## **Development Review Team Comments**

**Project Number:** PLT2023-00056

**Project Name:** Berkeley Center Subdivision

# BERKLEY CENTER SUBDIVISION

BOUNDARY, EXISTING PARCELS & EXISTING EASEMENTS DETAIL

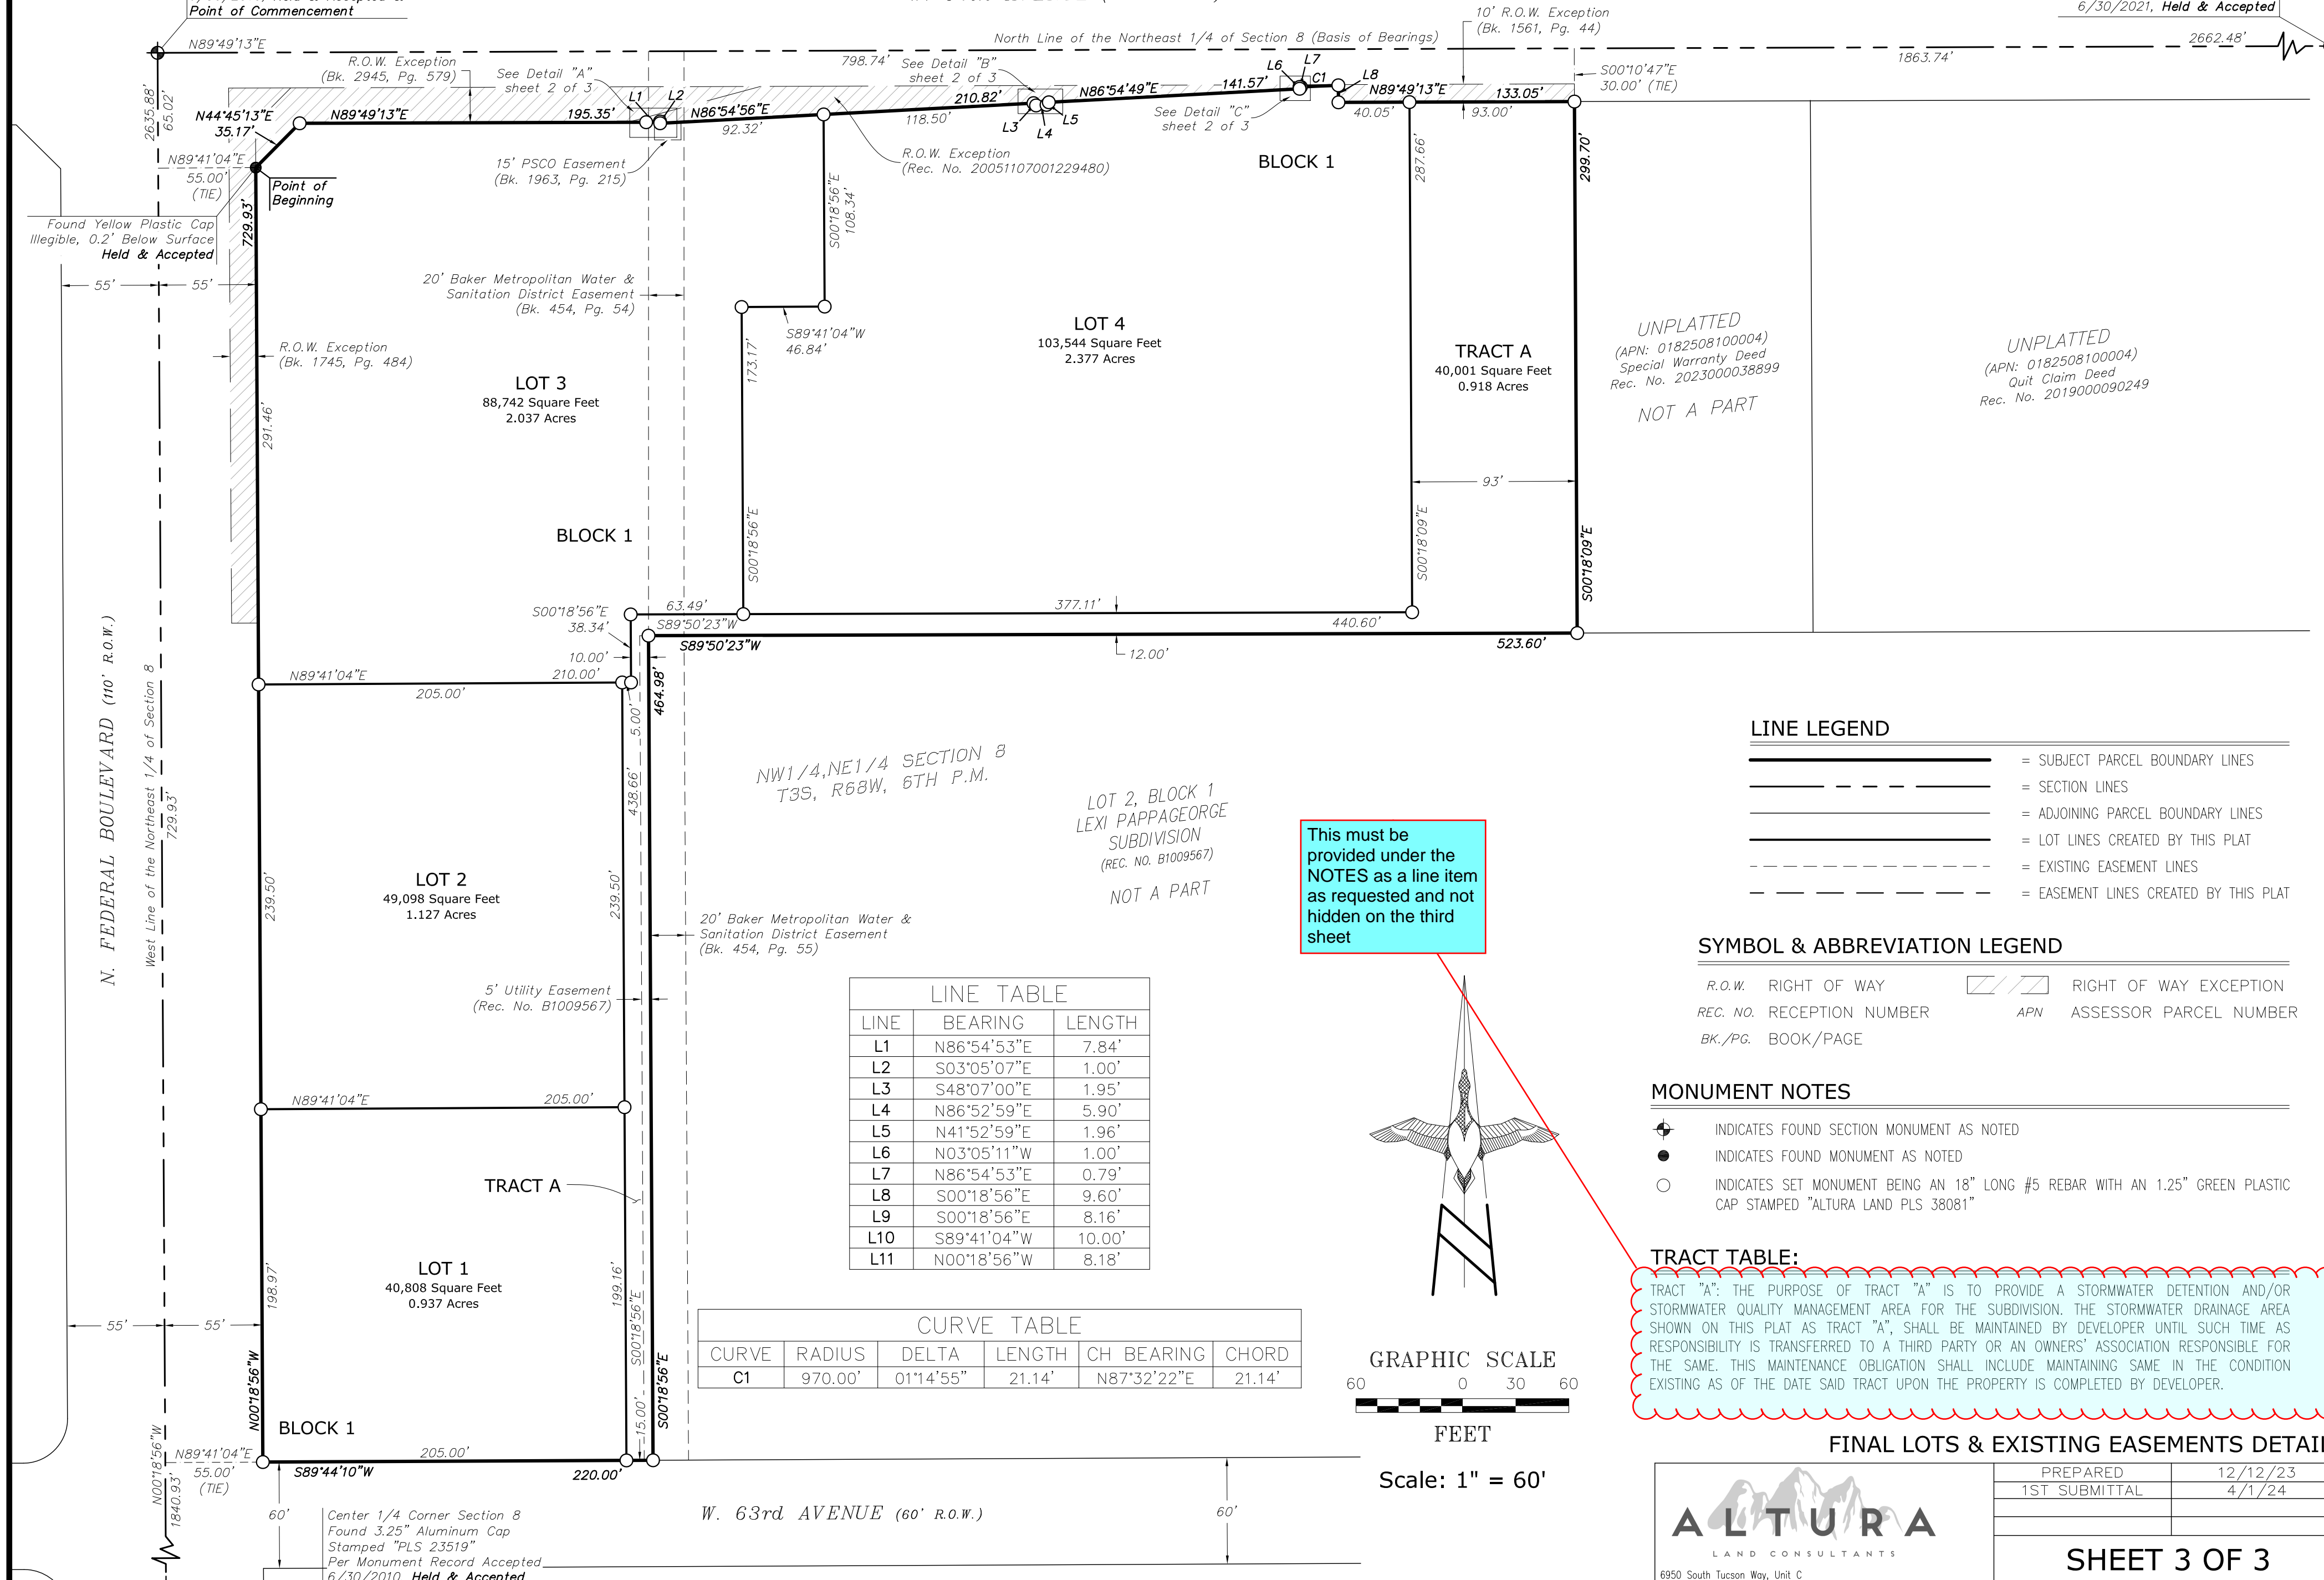
Provide a Land Use Chart  
-LOTS (lot sizes, sq. ft., ac.)  
-TRACT (size, sq. ft., ac., Use, ownership of this tract and who will maintain it)  
Total gross ac.

**FINAL LOTS & EXISTING EASEMENTS DETAIL**

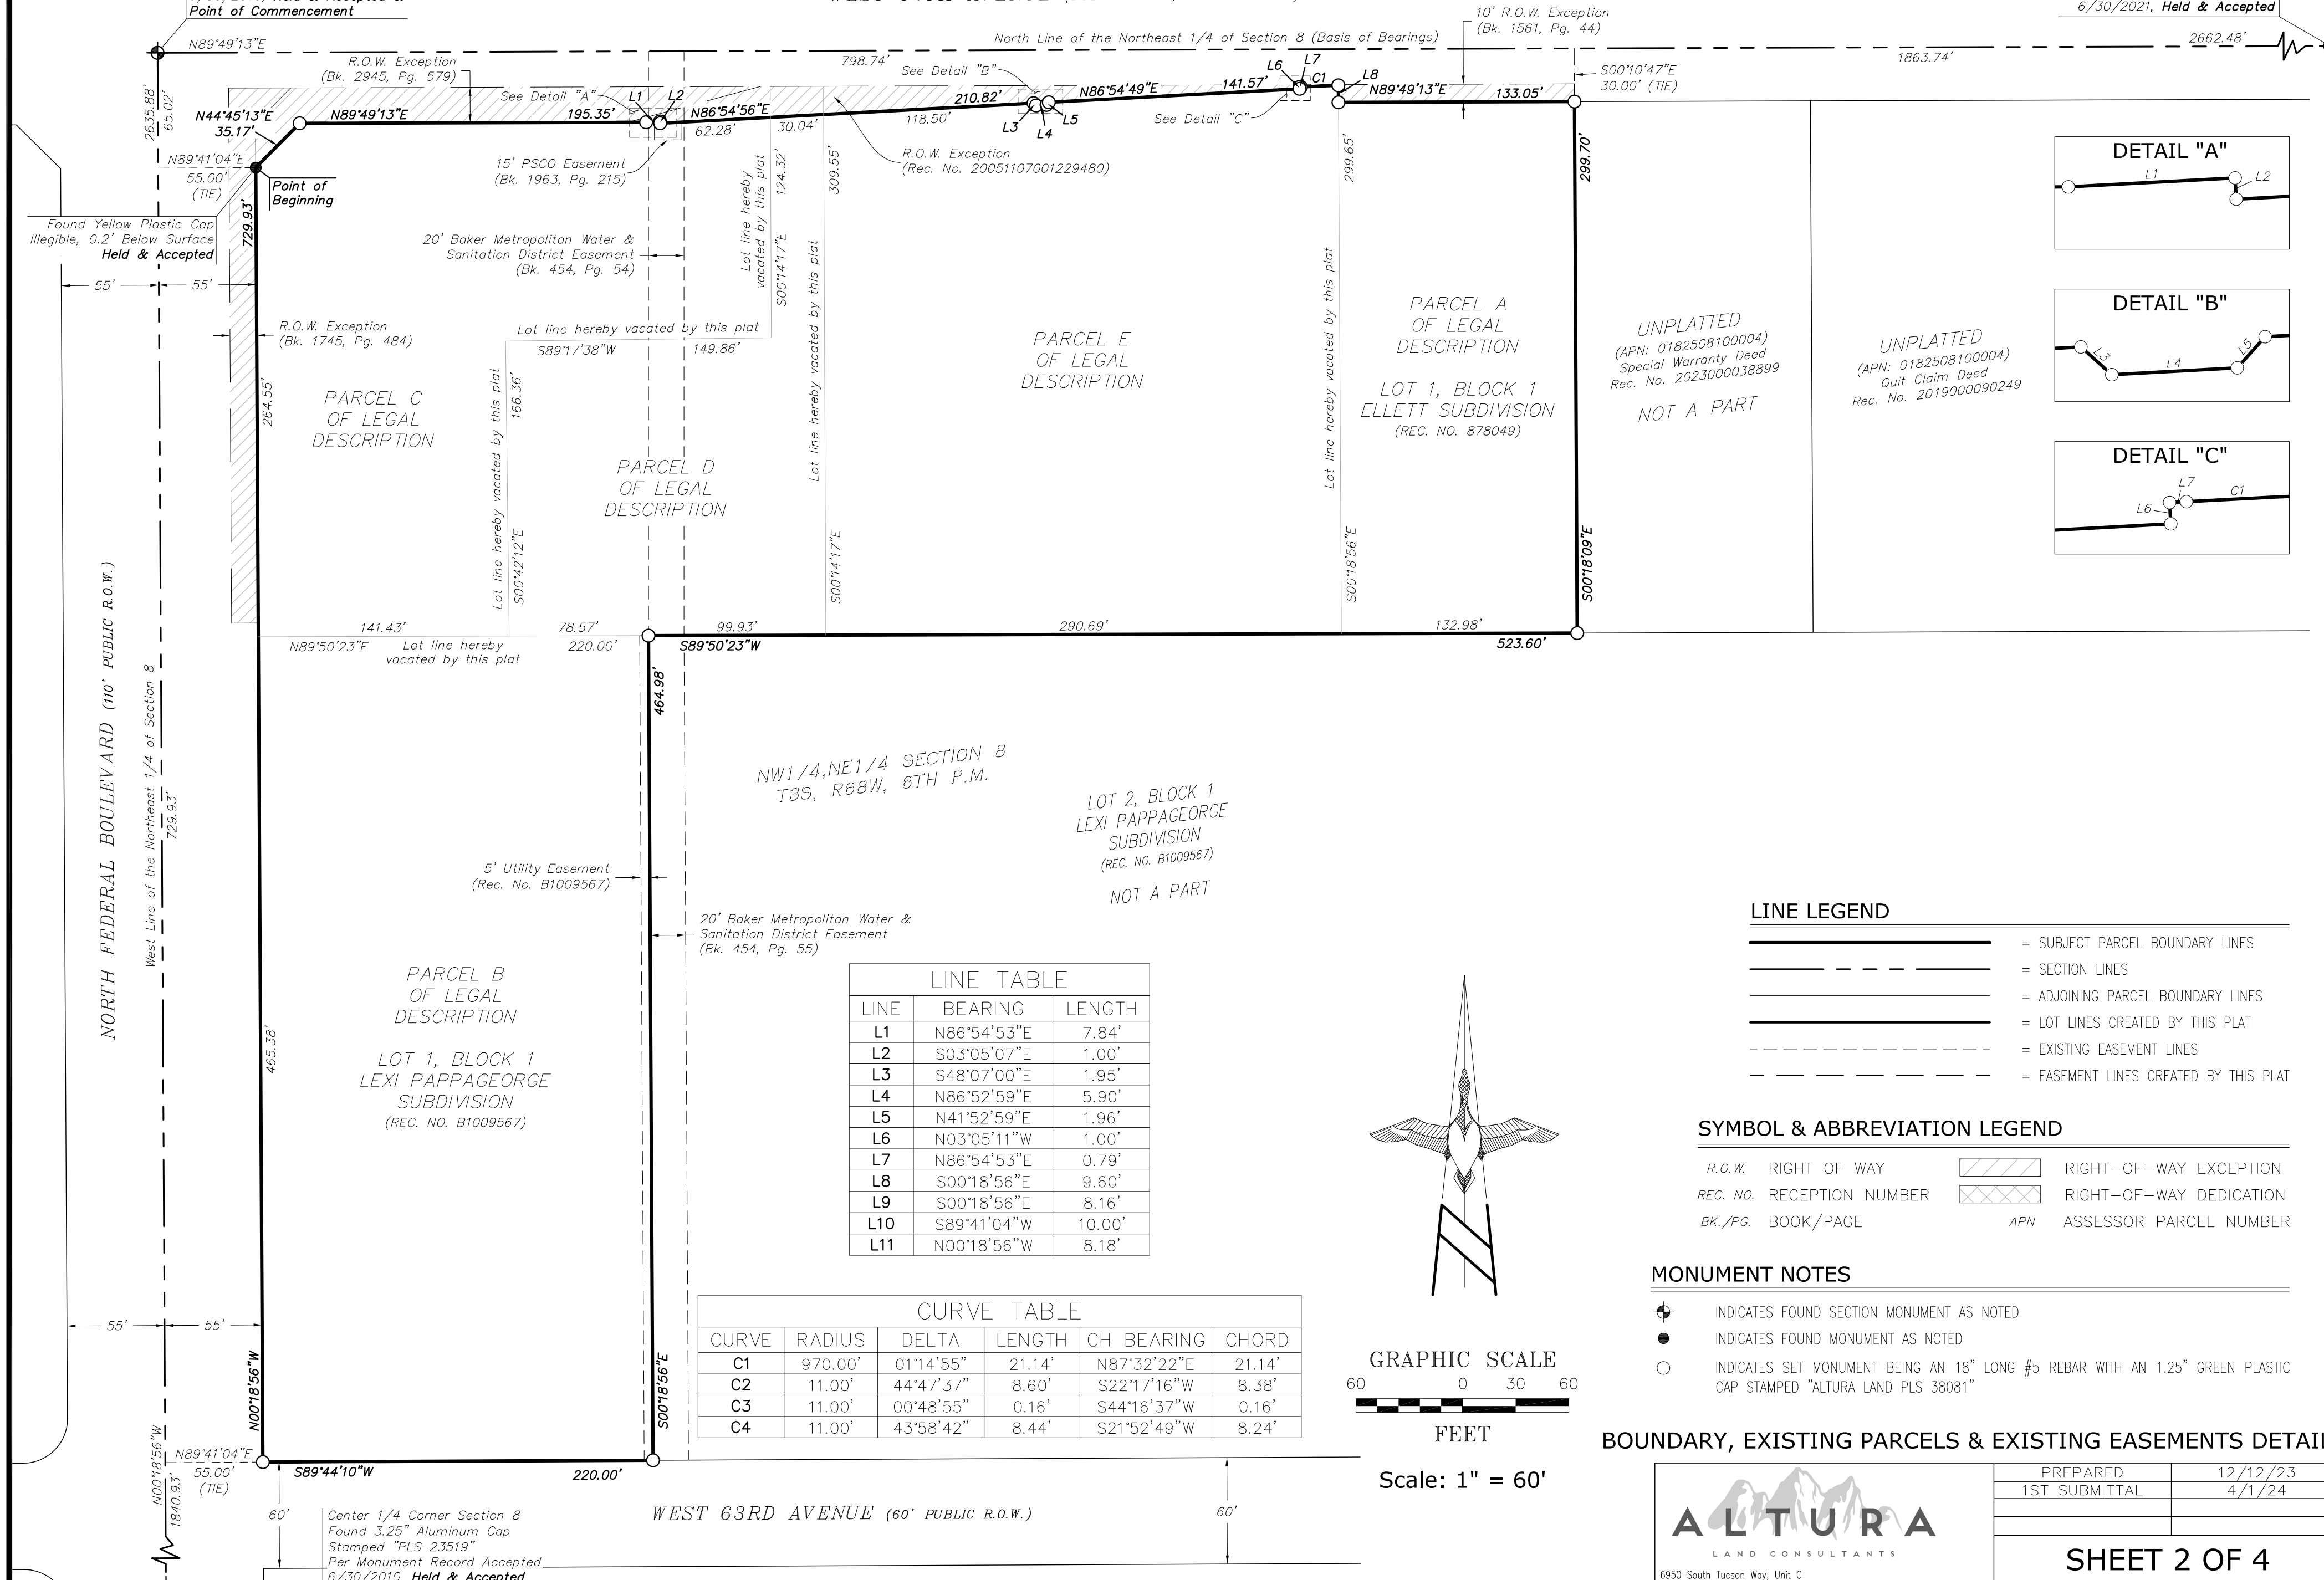
This must be provided under the NOTES as a line item as requested and not hidden on the third sheet
